• • ADDENDUM # 2 ••

**PROJECT NUMBER: 130012-59
EASTERN REGIONAL WATER RECLAMATION FACILITY
OPERATIONS BUILDING RENOVATION
DUE DATE: 08/27/2025 @ 1:30 PM**

**EASTERN REGIONAL WATER RECLAMATION FACILITY
OPERATIONS BUILDING RENOVATION
PROJECT NO. 130012-59**

**CHANGES TO BID DOCUMENTS – SPECIFICATIONS AND CONTRACT
DOCUMENTS**

FIRST FLOOR OVERALL DEMOLITION PLAN
**Eastern Regional Water
Reclamation Facility Operations
Building Renovation**

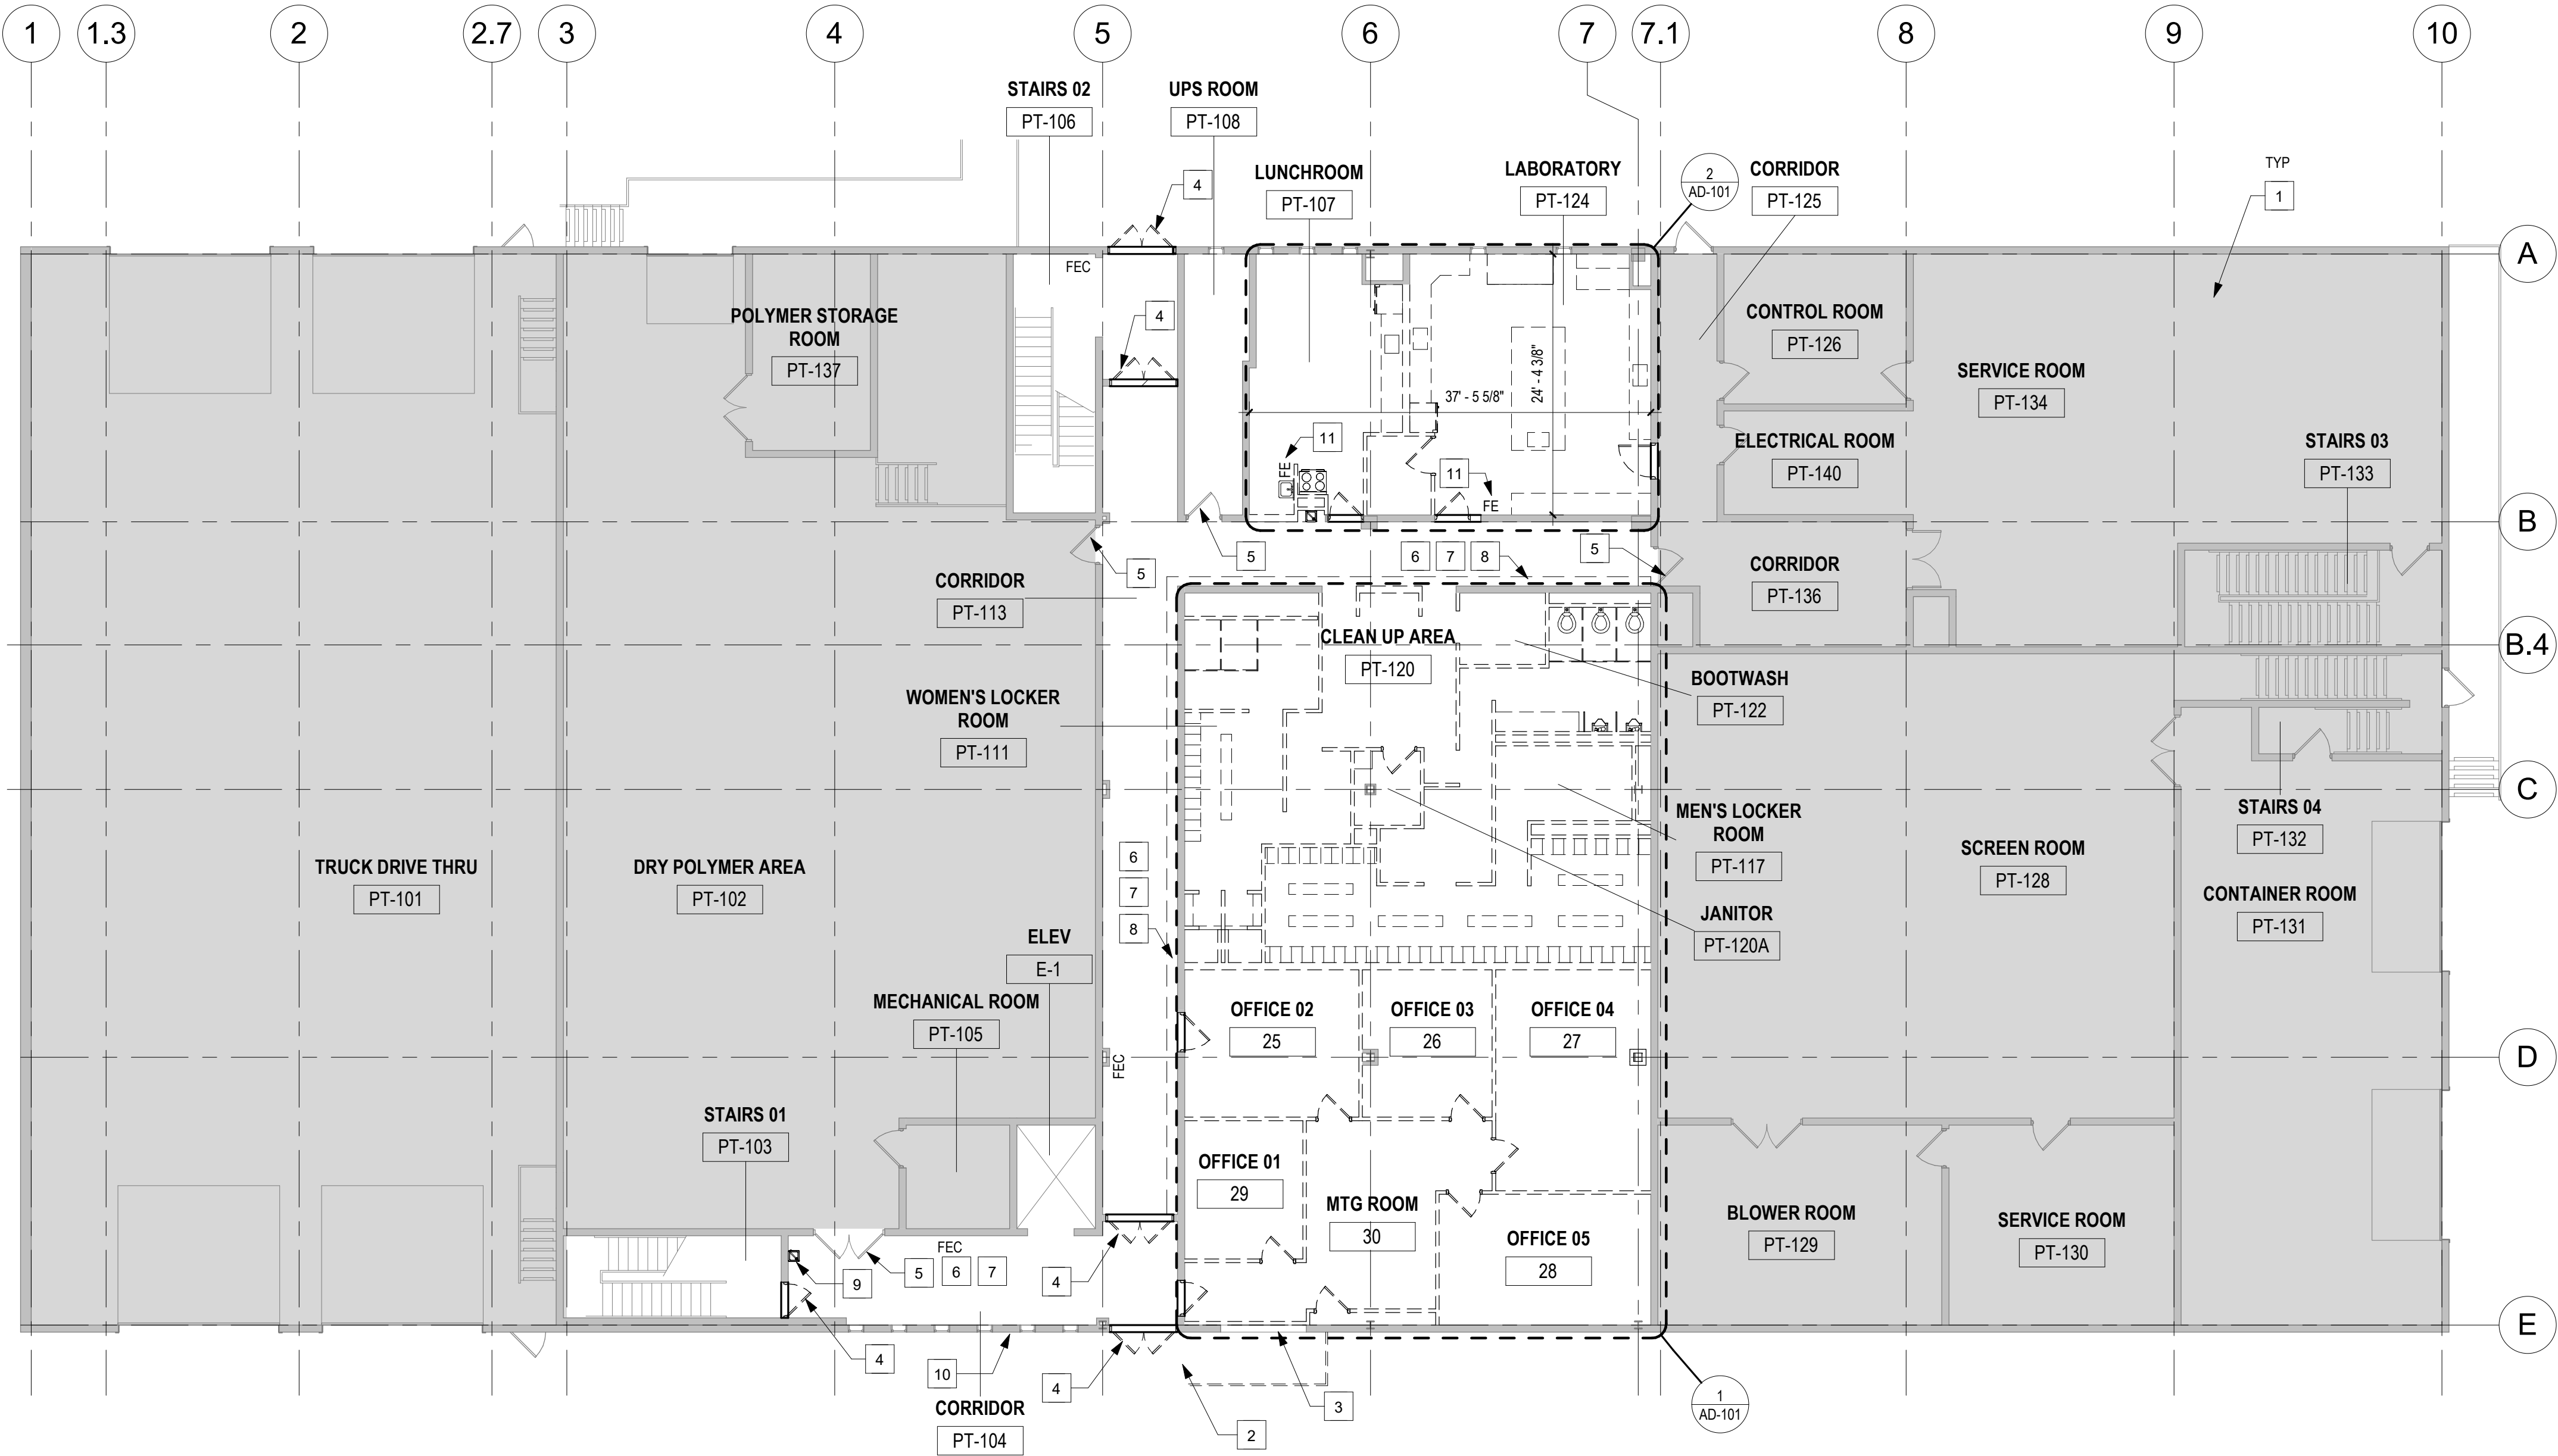
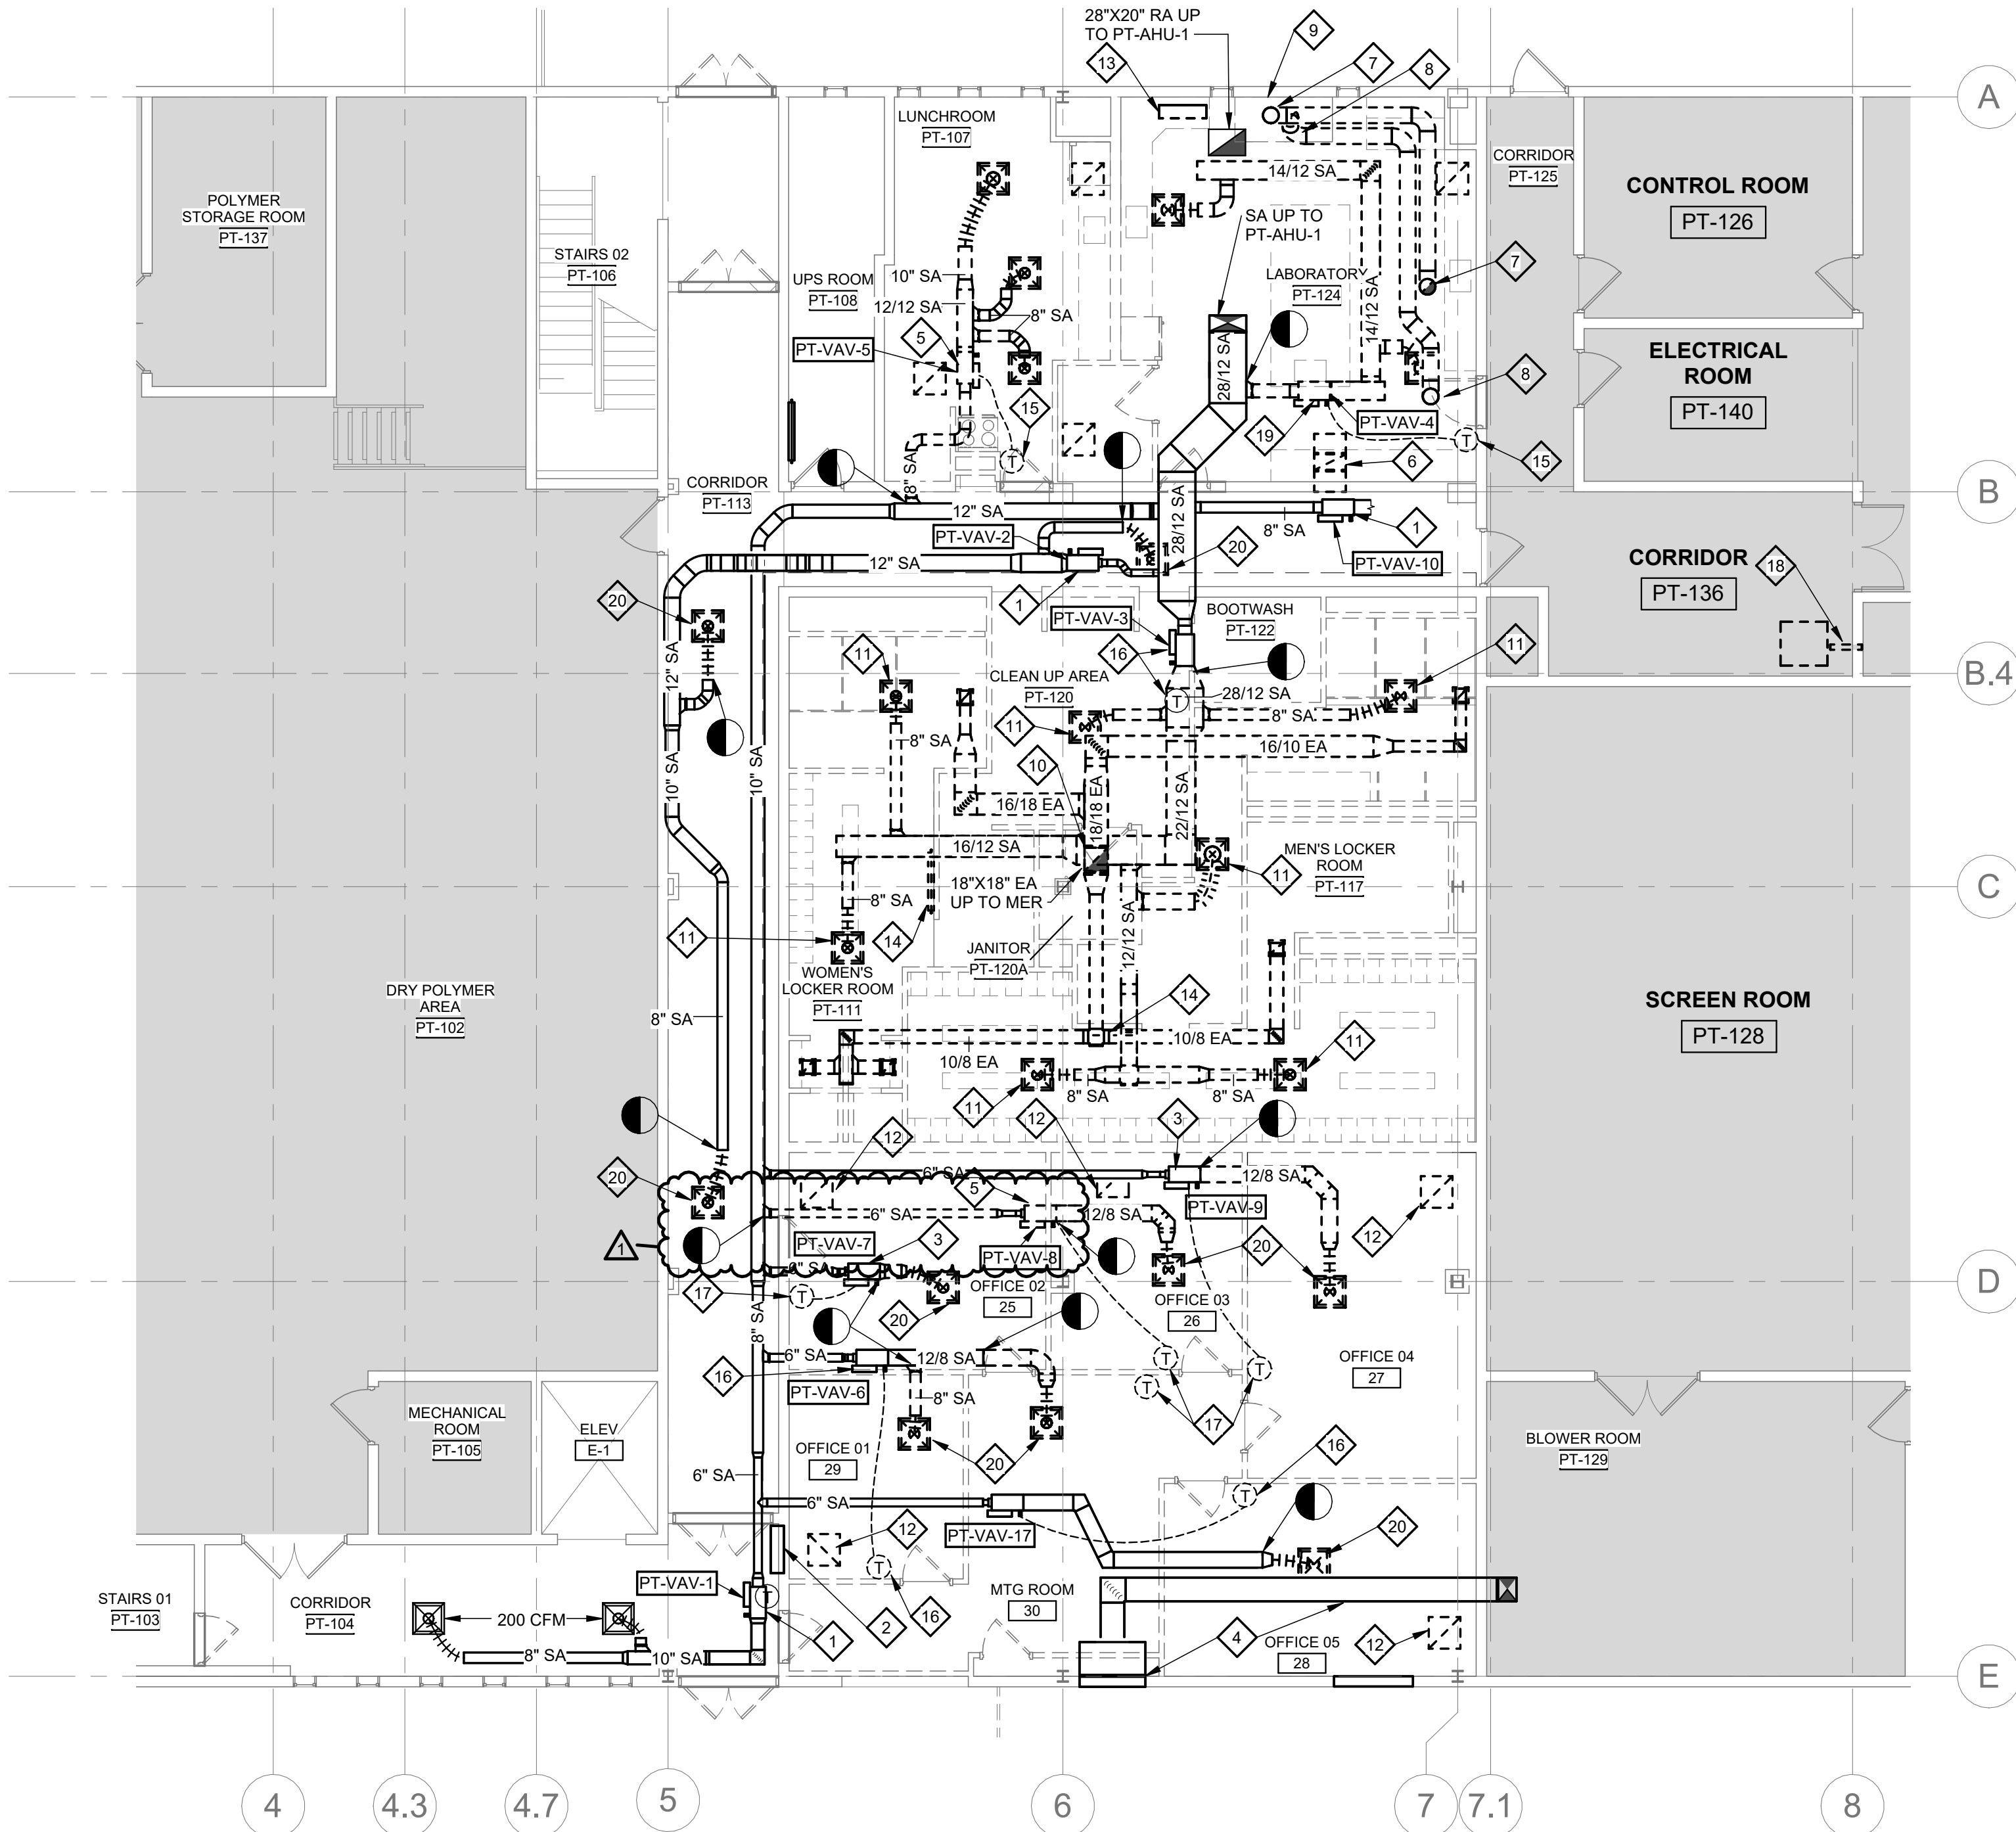
1. Sheet G-101 LIFE SAFETY PLAN
 - a. Update rated wall locations and code information per attached sheet.
2. Sheet AD-100 FIRST FLOOR OVERALL DEMOLITION PLAN

- a. Revise GENERAL NOTE E per attached sheet.
3. Sheet AD-101 FIRST FLOOR ENLARGED DEMOLITION PLANS
 - a. Revise CODED NOTES 5, 8, 38, 40 per attached sheet.

| DEMOLITION GENERAL NOTES | |
|--------------------------|--|
| E. | THE OWNER WILL OCCUPY ADJACENT BUILDING AREAS DURING CONSTRUCTION PERIOD. CONTRACTOR TO COORDINATE ACCESS TO ANY RESTRICTED AREAS WITH THE OWNER. LIFE SAFETY AND EVACUATION PLAN SHALL BE CREATED FOR EXISTING SPACES AND POSTED THROUGHOUT CONSTRUCTION DURATION. APPROVED EGRESS SHALL BE MAINTAINED. |

HVAC FIRST FLOOR DEMOLITION PLAN

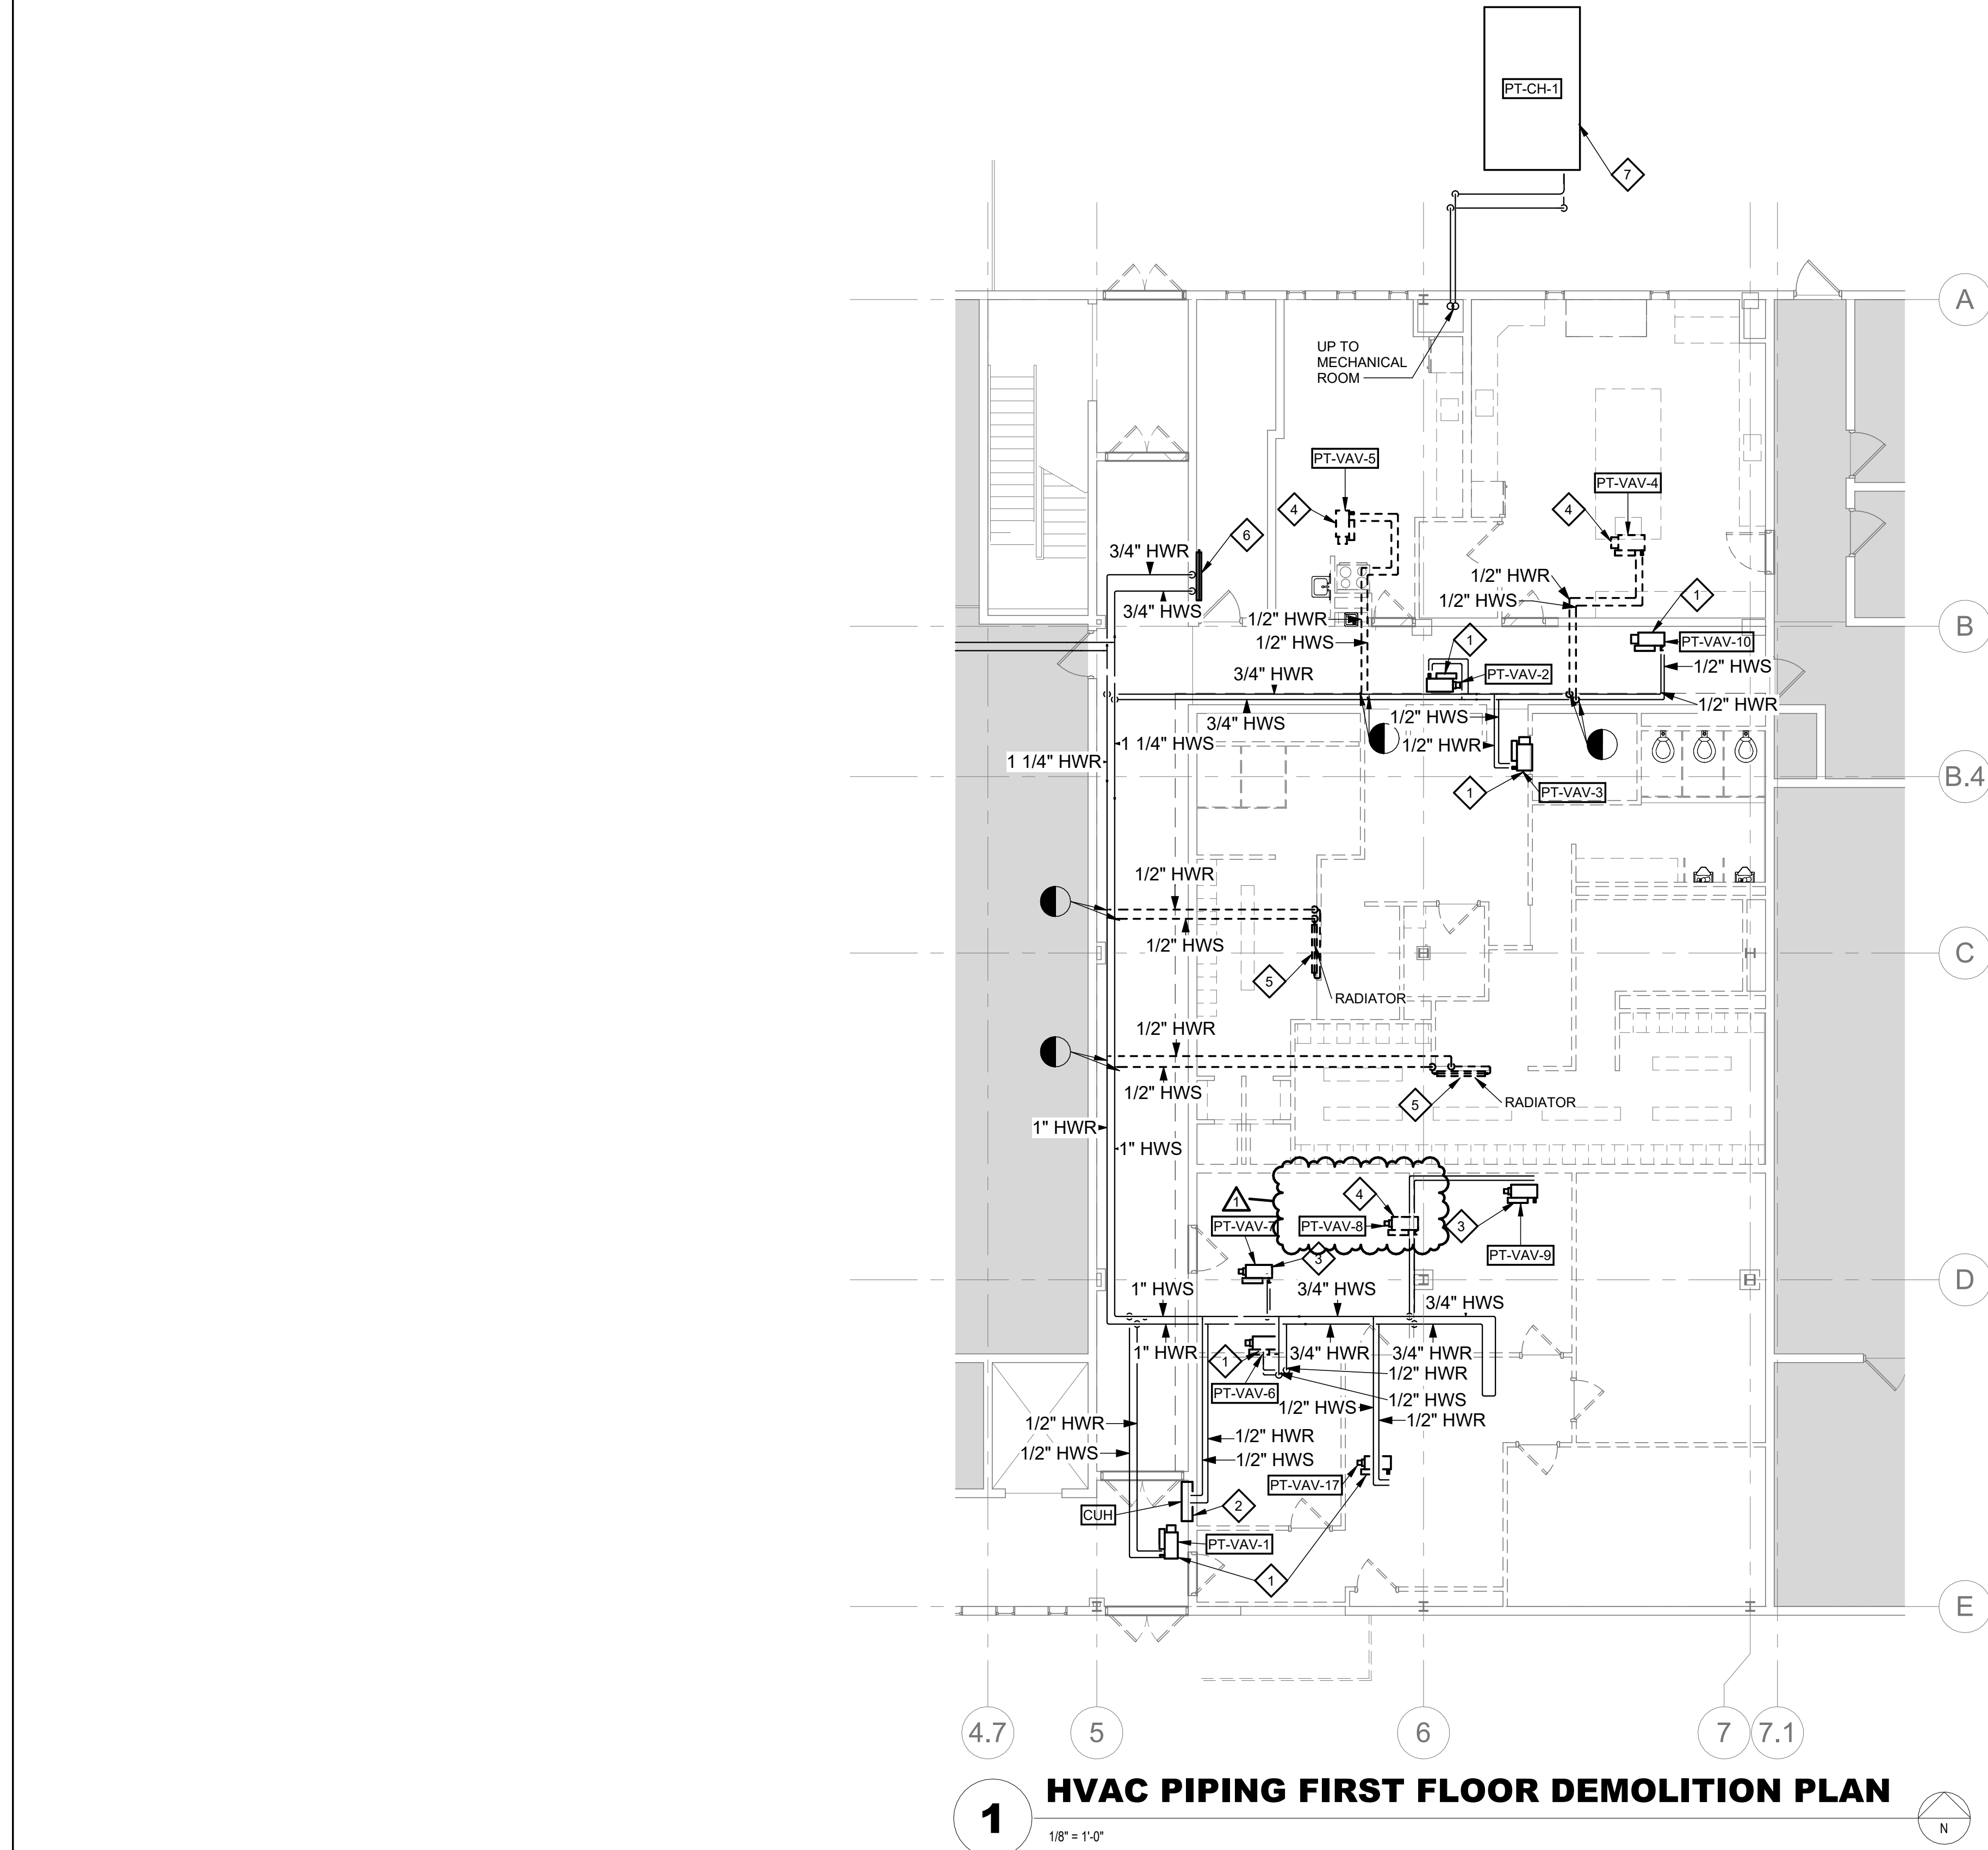
4. Sheet MD-100 HVAC FIRST FLOOR DEMOLITION PLAN
 - a. Remove VAV box PT-VAV-8 to avoid new 1-hour fire partition in new work per attached sheet.
5. Sheet MD-101 HVAC PIPING FIRST FLOOR DEMOLITION PLAN
